PROCUREMENT SPECIFICATION	AIR FORCE-NAVY AERONAUTICAL STANDARD	AN3067
NONE	SEAL ASSEMBLY - 3/8 INCH CONDUIT BOSS

AN3067 REV. 3
AMENDMENT 1
14 December 1994

SEAL ASSEMBLY - 3/8 INCH CONDUIT BOSS

This amendment forms a part of AN3067 REV. 3, dated 9 JUL 1954, and_. is approved for use by all Departments and Agencies of the Department of Defense.

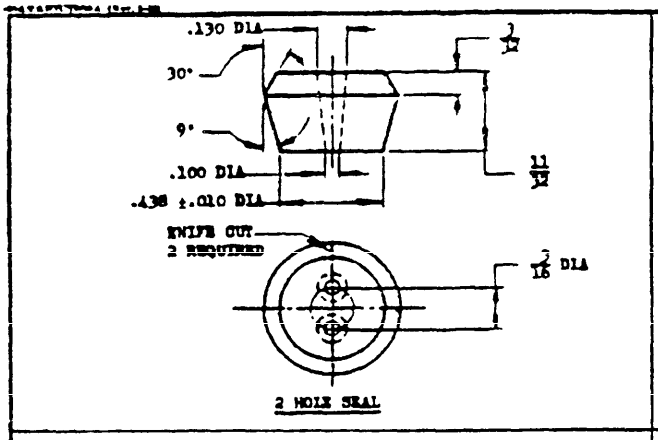
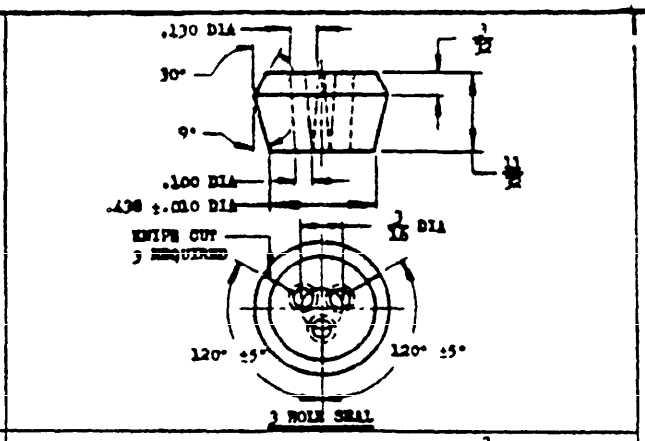
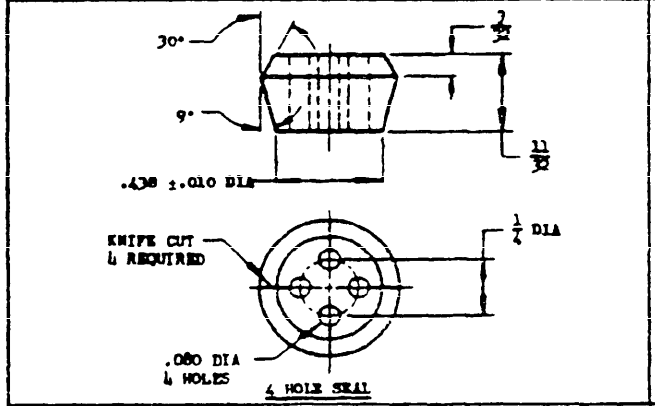
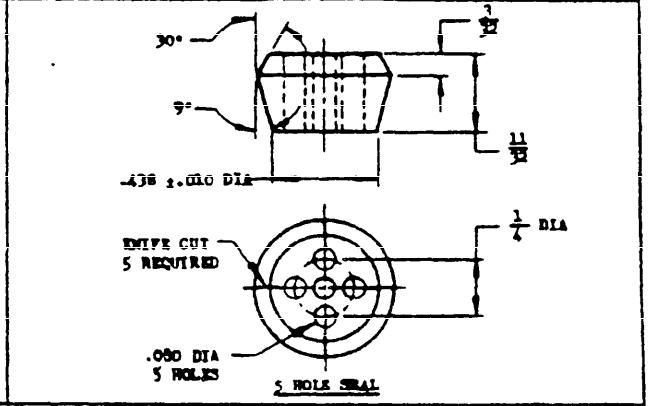
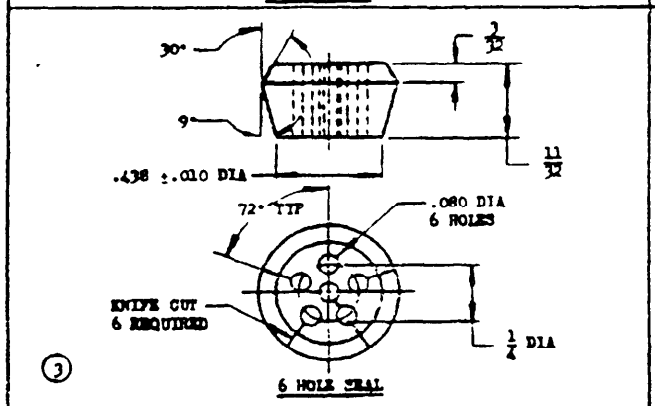
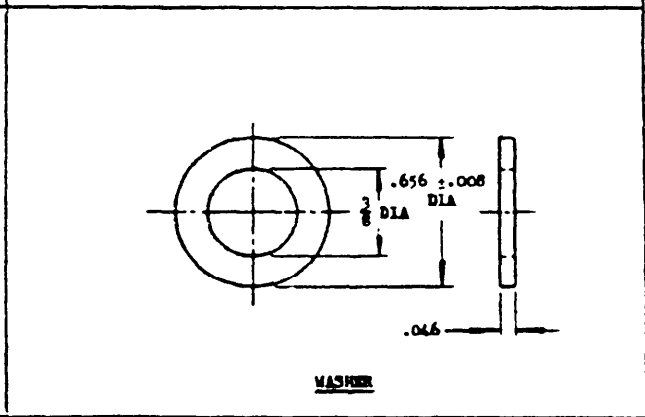
Delete:

MATERIAL: SEAL, SYNTHETIC RUBBER, SOFT,.
WASHER, FABRIC BASE PHENOLIC, TYPE FBG, SPECIFICATION MIL-B-15035.

Substitute with:

MATERIAL: SEAL, SYNTHETIC RUBBER, SOFT,.
WASHER, INSULATION, PLASTIC, LAMINATED THERMOSETTING, COTTON-FABRIC-BASE, PHENOLIC-RESIN (FBG), SPECIFICATION MIL-I-24768/14.
